1.0 Introduction

This document has been completed as a response to the request for additional information from South Dublin County Council regarding application reference SD22A/0342, received on 17th October 2022.

2.0 Additional Information - Architectural Elements

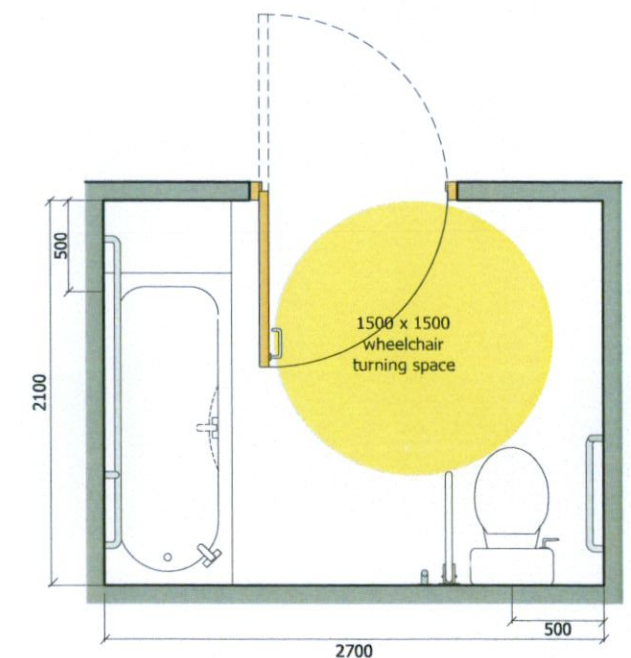
The applicant's Design Statement does contain 'typical apartment layout' drawings for a 1-bed unit and a 2-bed / 3-person unit. These do not appear to adhere to the proposed units, nor do they not show how the units are universally accessible, or how layouts could be revised as part of 'ageing in place' adaptations. The applicant should provide detailed unit layout plans by way of additional information, and these should highlight and how that the units are appropriately accessible and show how 'ageing in place' measures such as adaptations of bathrooms can be realised.

The following plans outline the proposed development with the previous building shown dashed in purple for comparison. We have also provided 1:100 floor plans of each level of the apartment building with dimensions for greater detail (drawings no. A2-30, A2-31, A2-32 and A2-33).

The building is approximately 300mm wider than the original application to provide for the enlarged bathrooms to meet the recommended guidelines for universal accessibility in the 'building for everyone'. This allows for the adaptation of the bathroom to a fully accessible layout if required. Please see extracted image of recommended bathroom from 'Building for Everyone' document.

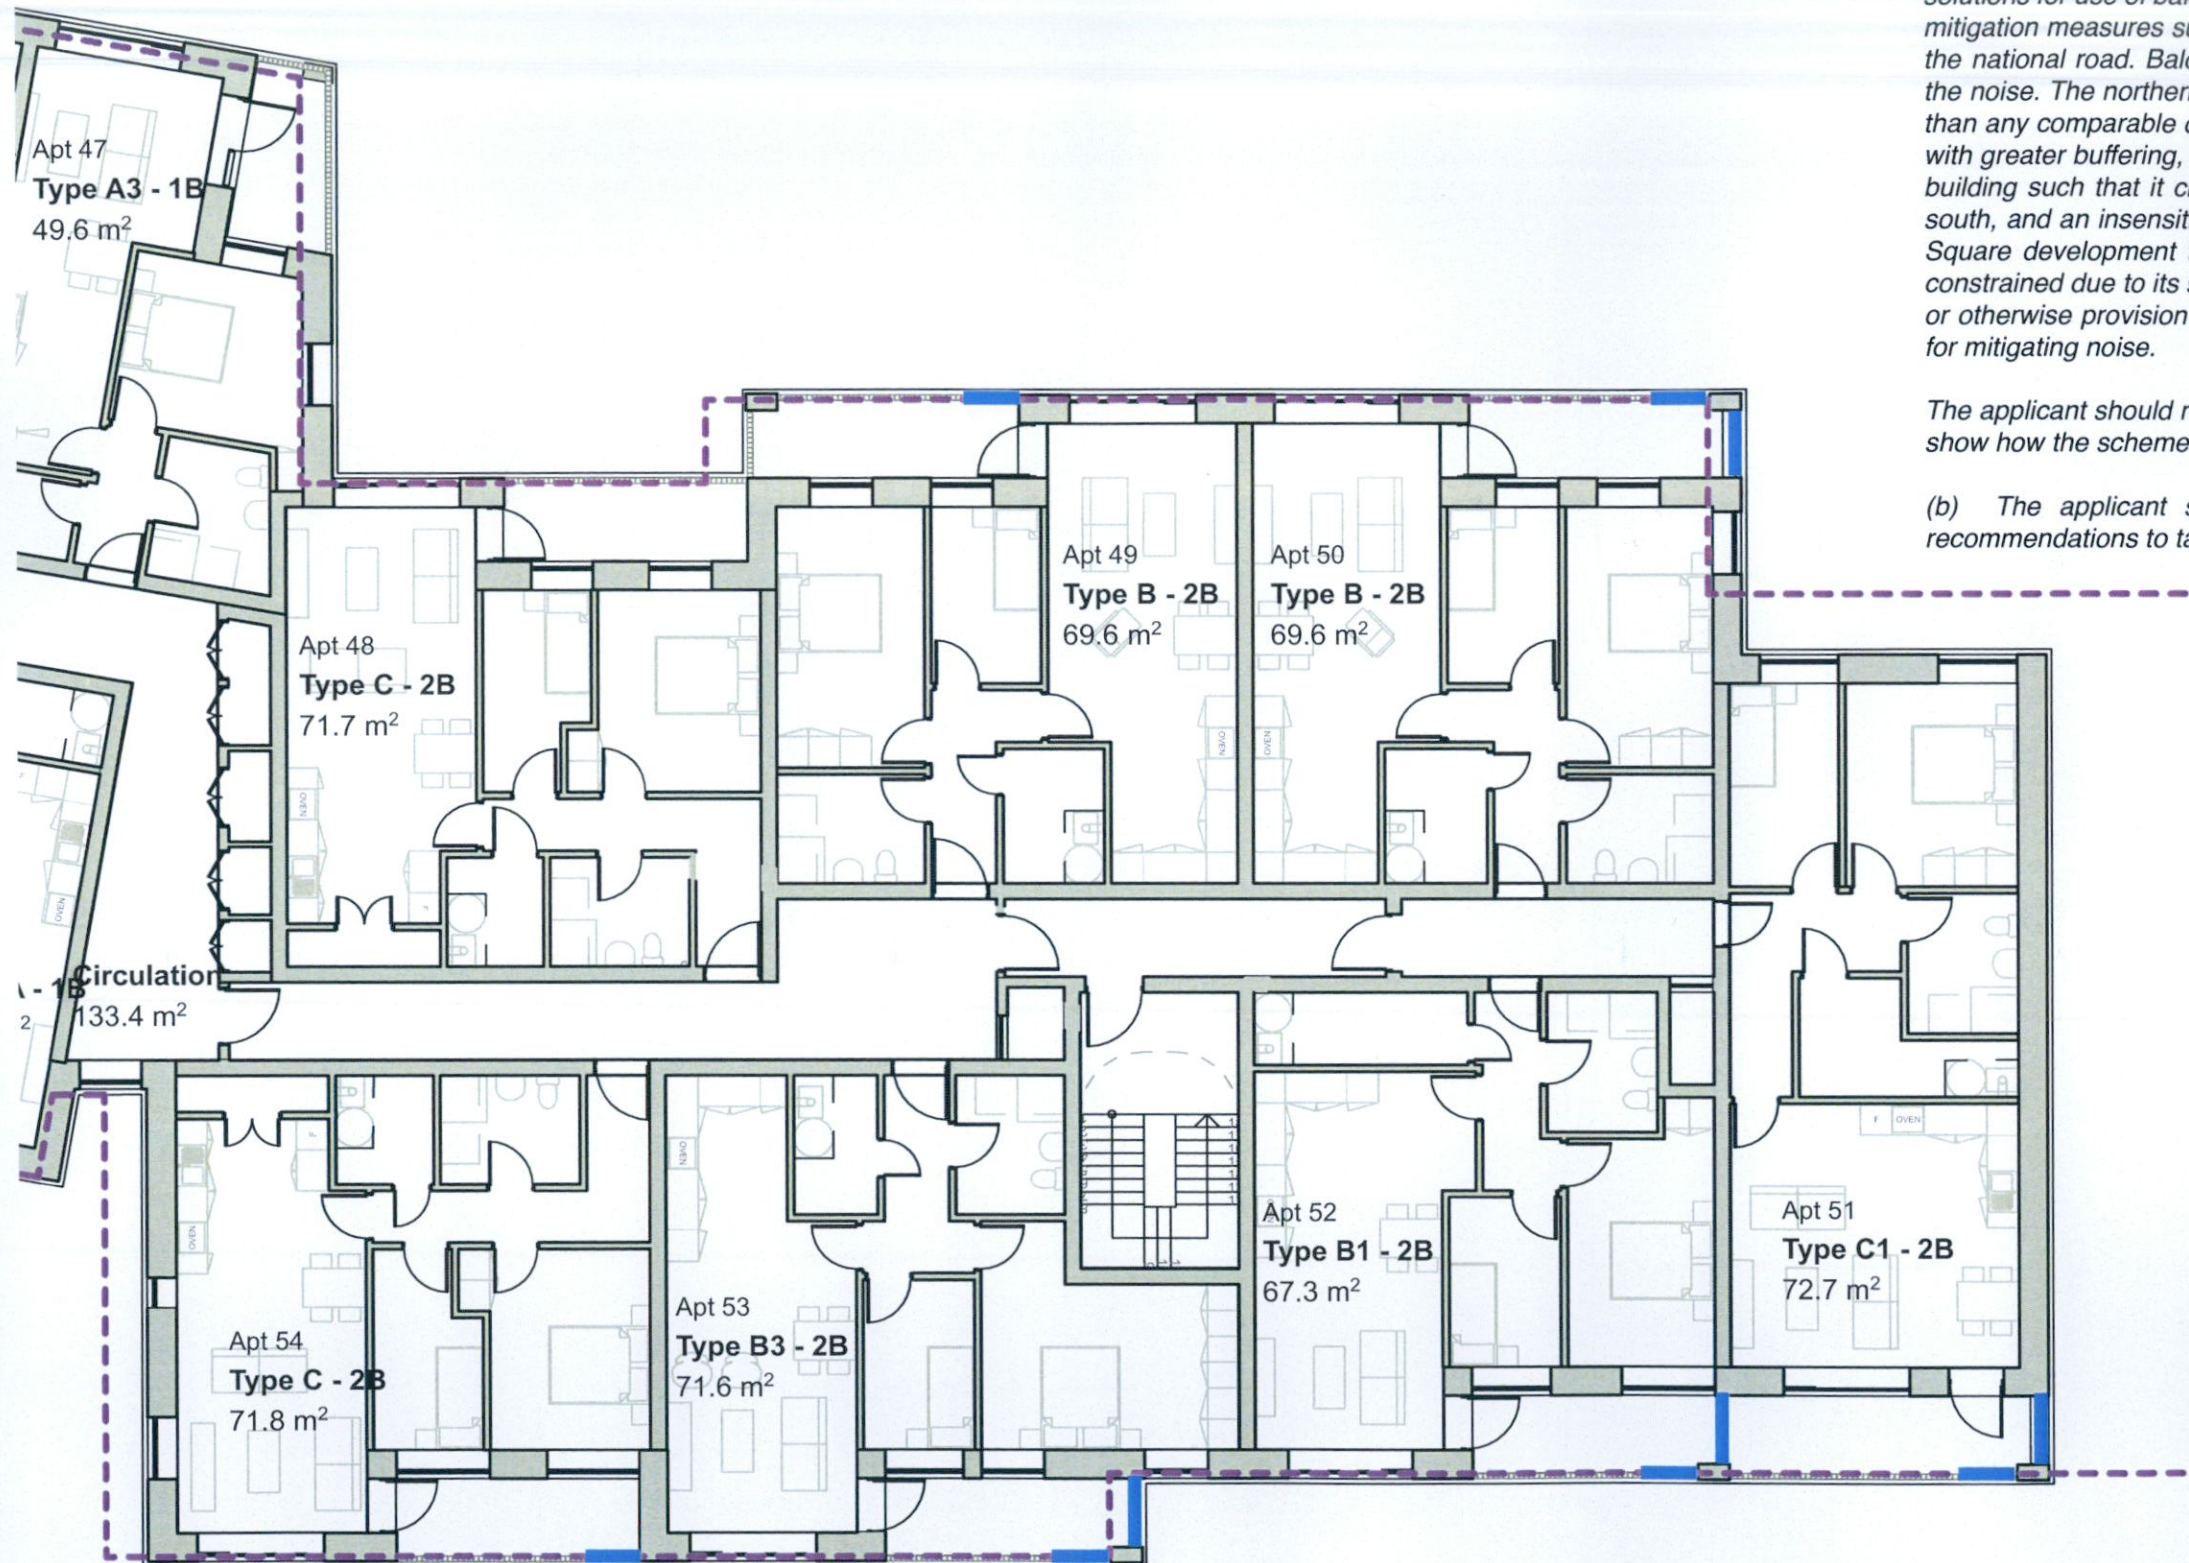
(a) The Noise Impact Statement provided by the applicant measure and provides mitigation solutions for internal noise levels within the development. The statement does not provide solutions for use of balconies or the communal open space. The proposed development lacks mitigation measures such as noise barriers. Set back landscaping and / or buffer zones from the national road. Balconies, particularly at higher levels, would be significantly affected by the noise. The northern facade of the proposed development would be closer to the N7 road than any comparable development of 4 storeys in Rathcoole. The design could be improved with greater buffering, with use of berms topped by hedgerows and trees; or by orienting the building such that it creates a noise barrier, with balconies and open space located to the south, and an insensitive use such as car parking located to the north, such as in the Eaton Square development to the east; or with the use of 'winter garden' balconies. The site is constrained due to its size and irregular shape. Expansion into the site to the north and west, or otherwise provision of a smaller development, would facilitate some of the above options for mitigating noise.

The applicant should respond to the above by way of additional information, and in particular show how the scheme would comply with Policy IE8 Objectives 4 and 7.

(b) The applicant should supplement their Noise Impact Assessment and resulting recommendations to take account of noise arising from aviation.

In response, to the noise impact to the external amenity spaces and balconies from the N7 road, we added the following mitigation:

- The site layout has been adjusted to remove any north facing balconies or windows directly facing the N7.
- Floor-to-ceiling frameless glass screens have been introduced on the corner facing the road as a sound barrier (blue lines highlighted on adjacent plan). It is impossible to introduce winter gardens to the balconies due to the service strategy which uses heat pumps and heat recovery that takes air in via the balconies. Enclosing this will reduce performance and the heating strategy would fail.

- There have been significant upgrades to the landscaping to mitigate the sound impact including but not limited to: increasing boundary fencing to 3.2m height for improved noise deflection; retaining all the existing trees along the northern site boundary; providing a 3.5m buffer space along the northern tree line.

- The building is 3.5m shorter than the original application which has been moved north 0.5m with the final building 3m further back from the N7 than previously proposed.

Proposed Landscape Plan to Application Reference SD17A/0036

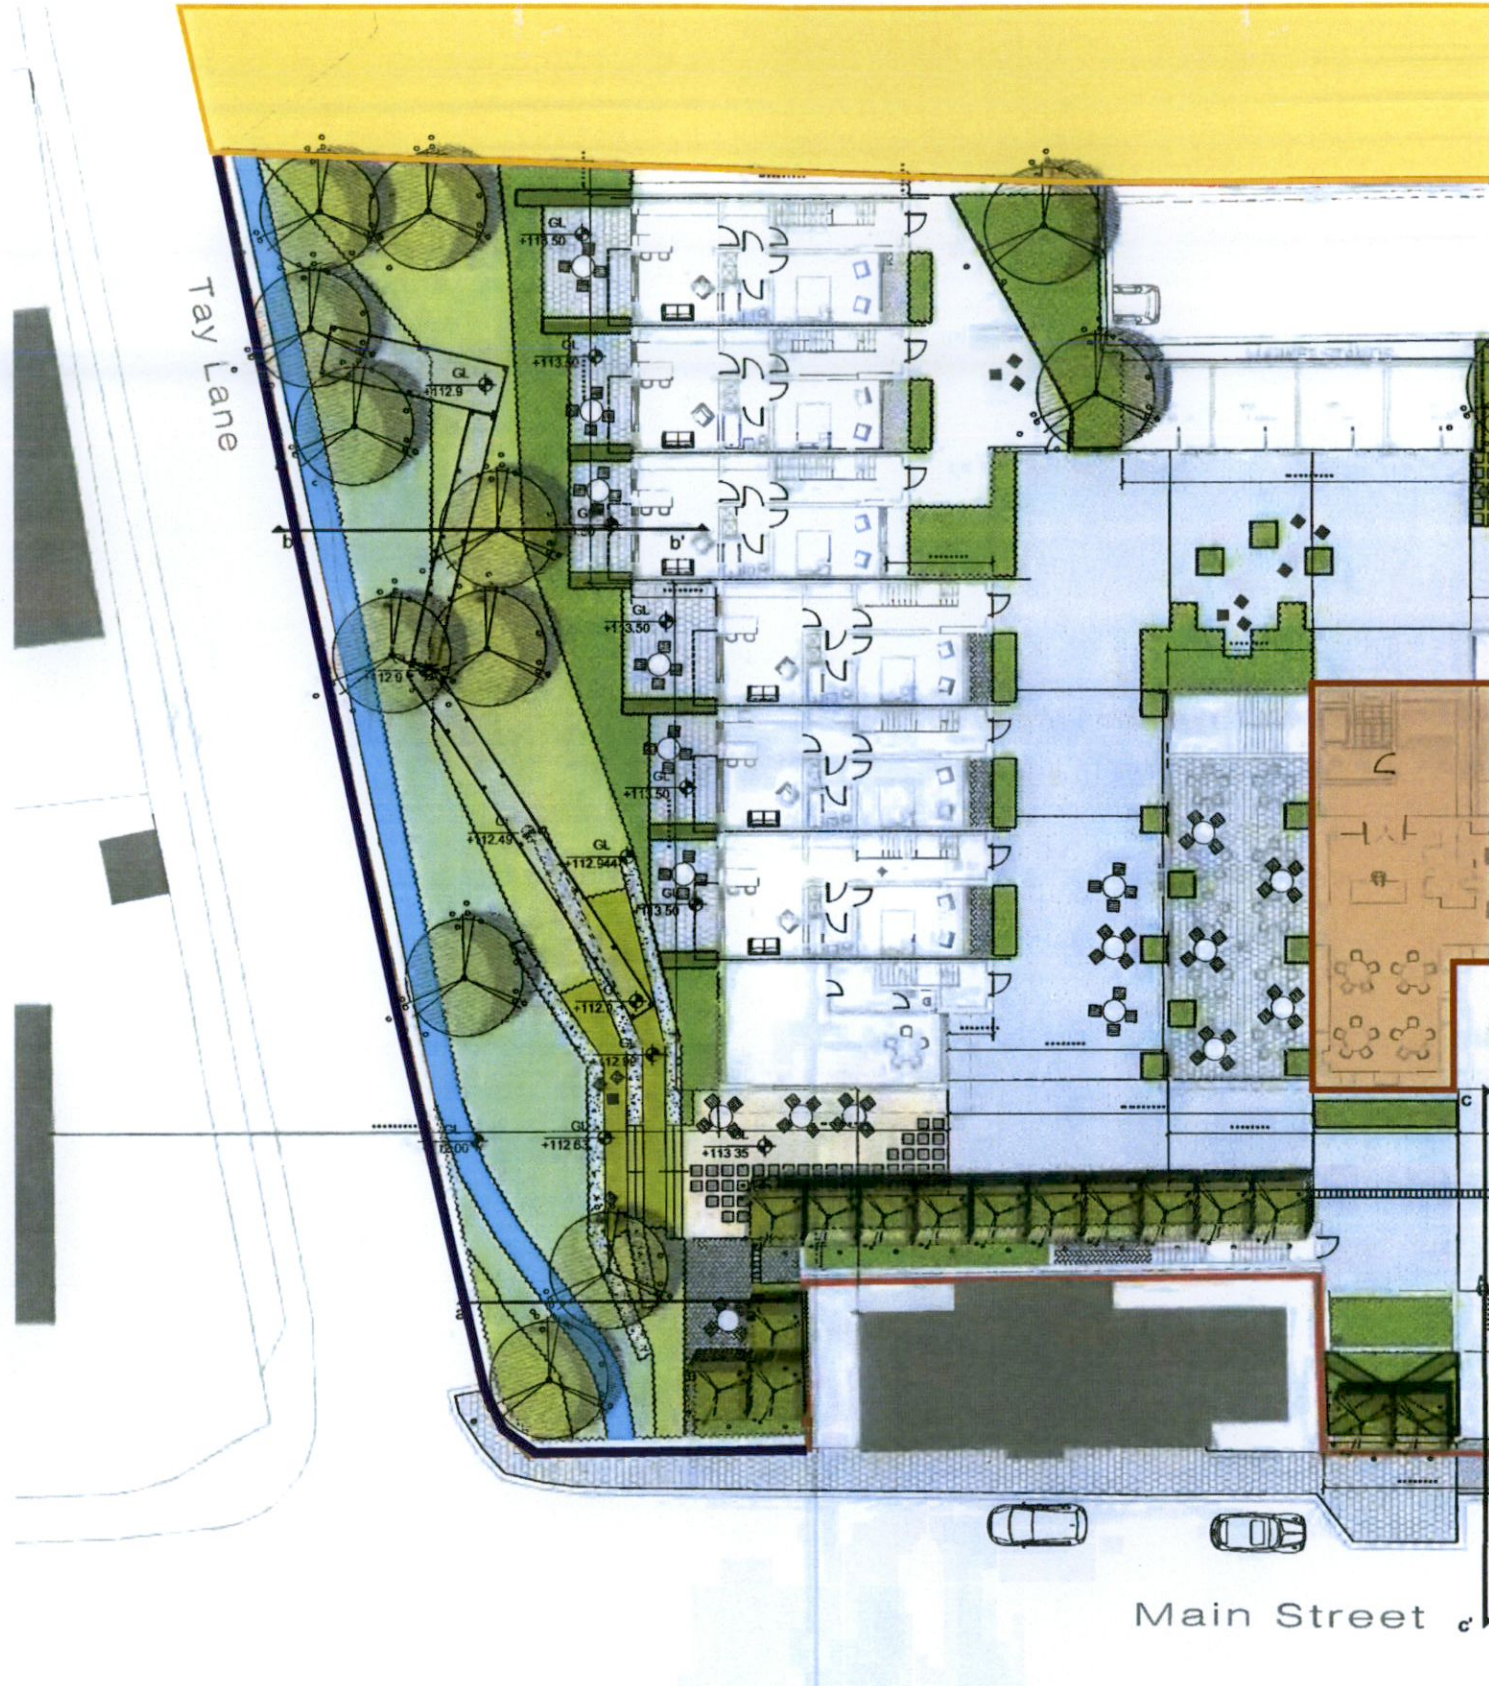
- (a) a Traffic and Transport Assessment of the nearby junctions, to confirm that the development will have no impact on the traffic flows on the Rathcoole main street.
- (b) a Stage 1 Road Safety Audit, with particular focus on the pedestrian access to the west and east of the development.
- (c) a revised layout of not less than 1:200 scale, showing a dedicated 2.0m wide footpath on the east side of Tay Lane from the Rathcoole main street to the access of the proposed development.

(c) The proposed footpath to the east of Tay Lane has been analysed in detail but is proving impractical to provide. A 2.0m wide footpath would reduce the carriage width to below the minimum recommendation. A shared surface for vehicular and pedestrian use was considered but this would be dangerous, unnecessarily putting pedestrians and vehicles in conflict, particularly considering there is a generous footpath currently in place on the other side of the road.

The existing stone wall to the boundary of Glebe House, the site directly to the south of the application site, is a protected structure and would not be permitted to be removed or adjusted in any way. In addition to the proposed opened culvert on the east side of this boundary wall, there is very little scope to modify or adjust the existing road layout to accommodate the 2.0m wide footpath.

Considering the existing constraints, it is proposed that the improvements to the lighting of the existing footpath to the western side of Tay Lane (please refer to the External Lighting Strategy document included with this application), along with the currently proposed crossing point to the site, is the safest option for pedestrian access to the proposed site and beyond.

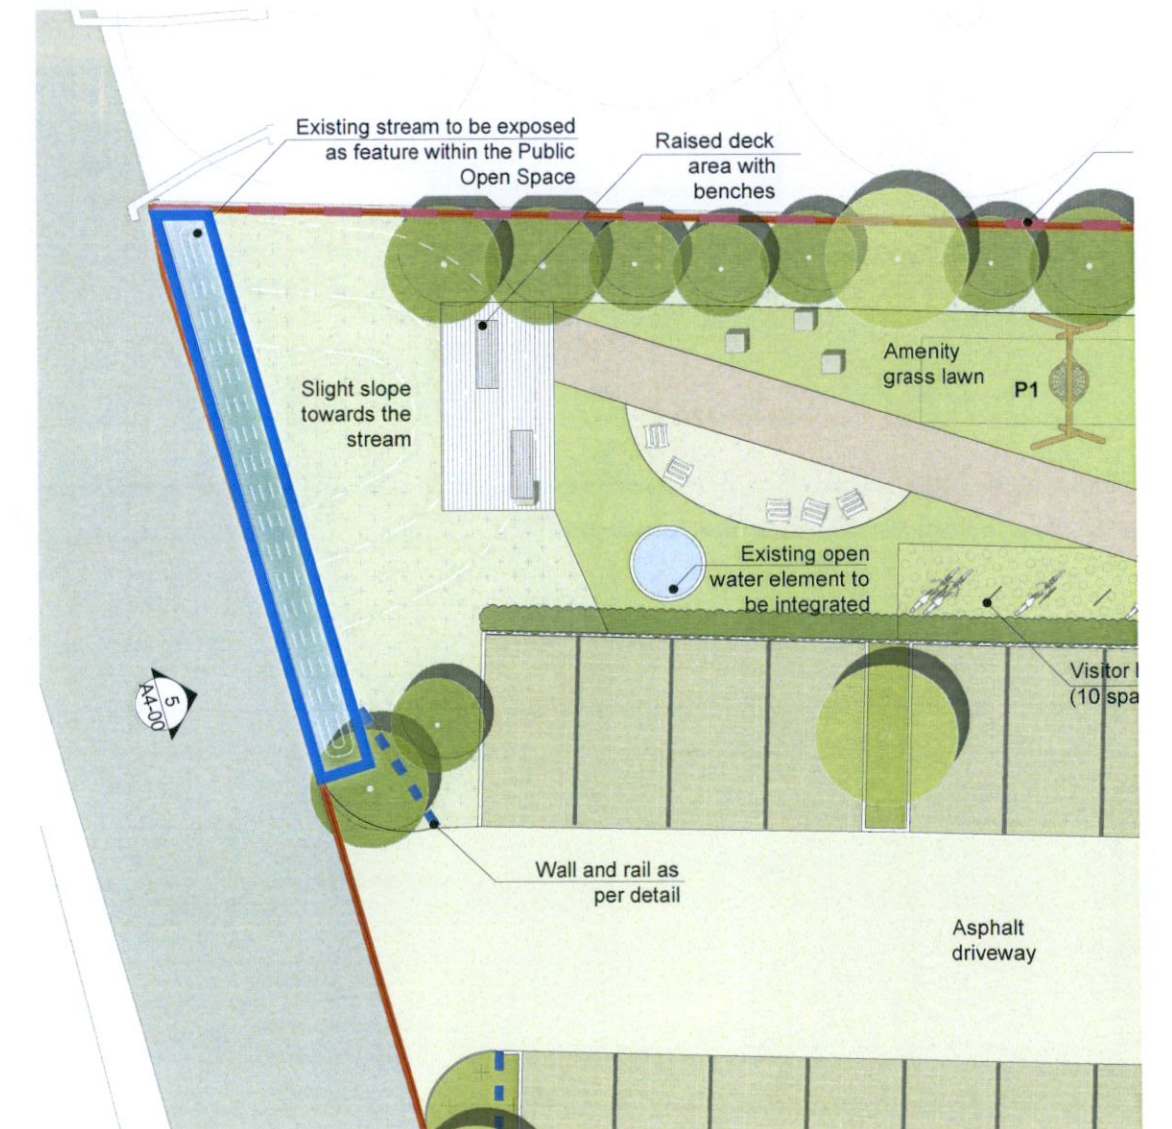
It is noted that a stream running up the west of the site has been culverted and diverted through an underground pipe. This stream is to be uncovered as part of the permitted development SD17A/0036. It is council policy to uncover culverts as per Policy G13 Objective 4 of the County Development Plan, and section 12.4.3. The applicant is requested to revise their landscape and drainage plans in order to uncover this watercourse and integrate it into their landscape proposals.

Please refer to the updated landscape drawings that are included with the additional information provided. The existing culvert is to be opened up and integrated into the public open space at the front of the scheme, facing onto Tay Lane.
